# United States Patent and Trademark Office

|  |             | · · · · · · · · · · · · · · · · · · · |                     | ***              |
|--|-------------|---------------------------------------|---------------------|------------------|
| 10/576,420   | 04/19/2006  | Shunpei Yamazaki                      | 740756-2955         | 9417             |

### DETAILED ACTION

FIG. 22B

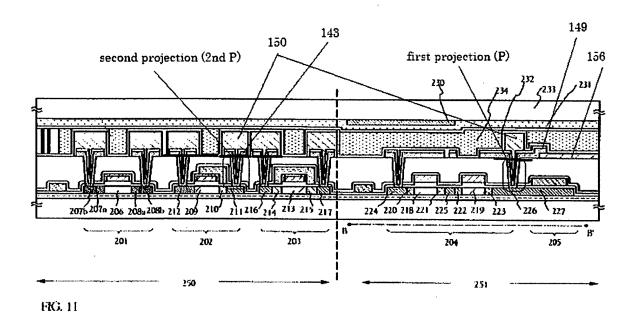
Regarding Claim 1, Arao, embodiment 7, FIGS. 22A-22D does disclose a liquid crystal display device comprising:

a thin film transistor (1204, FIG. 22A, col. 27, lines 47-49);

a projection (P, FIG. 22B {as shown above}, note that P included 1256b·c) over a drain electrode (1256a, col. 27, lines 45-50) of the thin film transistor (1204); and a pixel electrode (1257, col. 27, lines 44-46) connected to the film projection (P), wherein the projection has a stacked structure (1256b·c, col. 27, lines 30-40).

Regarding Claim 4, Arao, embodiment 7, FIGS. 22A-22B further teaches the liquid crystal display device according to claim l, wherein at least one of the drain electrode

(1256a, FIG. 22B), and the projection (P) contains one selected from the group consisting of titanium, and aluminum (col. 27, lines 34-41).
